Product Change Notification

Change Notification #: 110911 - 00
Change Title: Intel(R) Server System SR1630BCR, Single, PCN 110911-00, Product Design, Product Design, Change CPU socket protective cover
Date of Publication: August 02, 2011

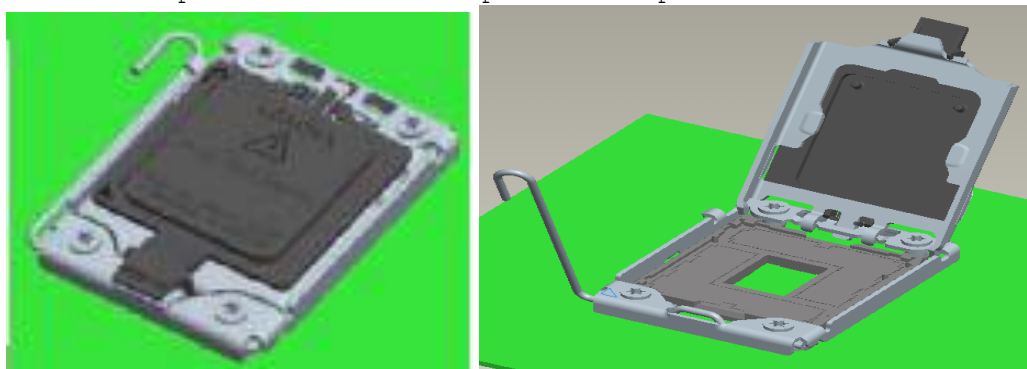
Update the CPU protective cover to reduce the possibility of pin damage. Below is a picture of the new protective plate:

CPU socket protective cover change has no functional impact but may require process change when inserting a CPU
